# Staff Report

Knoxville Historic Zoning Commission

File Number: 11-H-25-HZ

**Location:** 218 Cansler Ave. **Parcel ID** 94 K D 005  
**District:** Mechanicsville H  
**Zoning:** RN-2 (Single-Family Residential Neighborhood)  
**Description:** Folk Victorian, c.1910

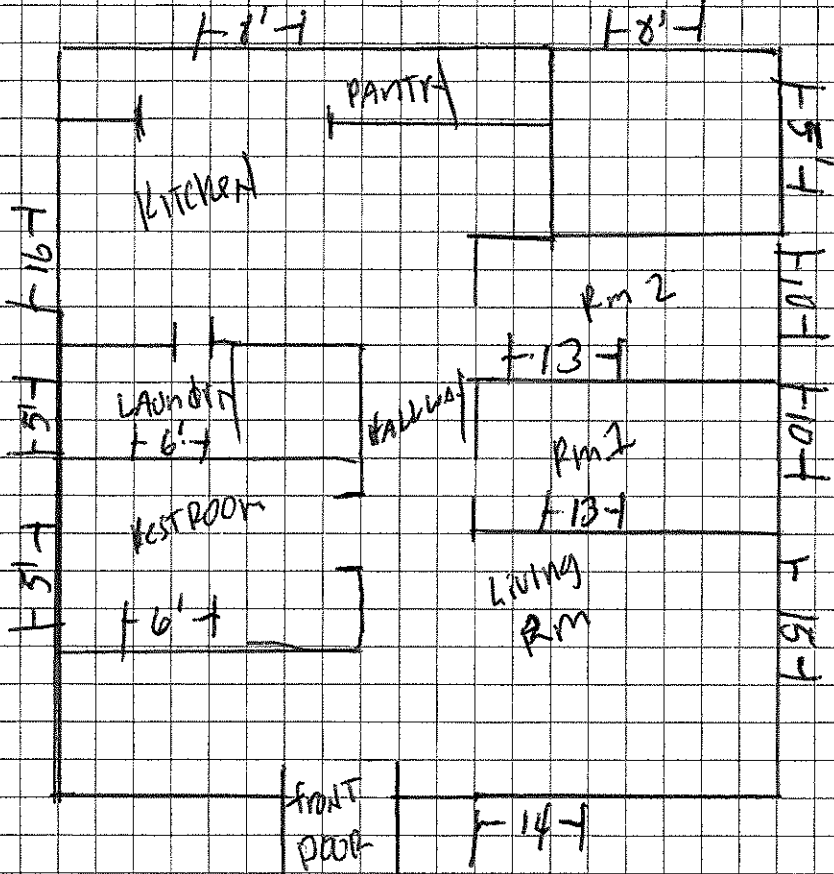
Revisions to 11-D-24-HZ and 4-F-24-HZ. Proposed installation of 1/1 vinyl-clad wood double-hung windows (Andersen 200 Series) instead of the 1/1 wood double-hung windows approved with 4-F-24-HZ. Requesting to fully deconstruct and rebuild the structure matching the elevations and site plan approved with 11-D-24-HZ, which reflect the historic footprint and design.

3. Vinyl replacement windows have frequently been denied in Mechanicsville, and vinyl-clad wood replacement windows were denied in 2012 (2-L-12-HZ). Only wood replacement windows have been approved, except for a 2014 case in which aluminum-clad wood windows were approved to replace deteriorated wood windows on a brick commercial building within the overlay (8-G-14-HZ). Aluminum-clad wood windows have been approved for new construction and outbuildings. The proposed 1/1 double-hung vinyl-clad wood windows do not meet the guidelines, which state that “[replacement windows] must be the same materials as the original windows, which are generally wood.” In the opinion of staff, aluminum-clad wood can be appropriate for replacement windows because so little of the original materials on the house are extant, and the house has had vinyl windows since at least 2007.

- 1) denial of proposed vinyl-clad wood windows;
  - 2) approval of 1/1 double-hung wood or aluminum-clad wood windows, with final specifications to be approved by staff;
  - 3) no mechanical demolition be undertaken, but allowing for the use of mechanical equipment to disassemble the building; and
  - 4) any salvageable historic materials be identified during reconstruction and reused, particularly the timbers that frame the roof.
-
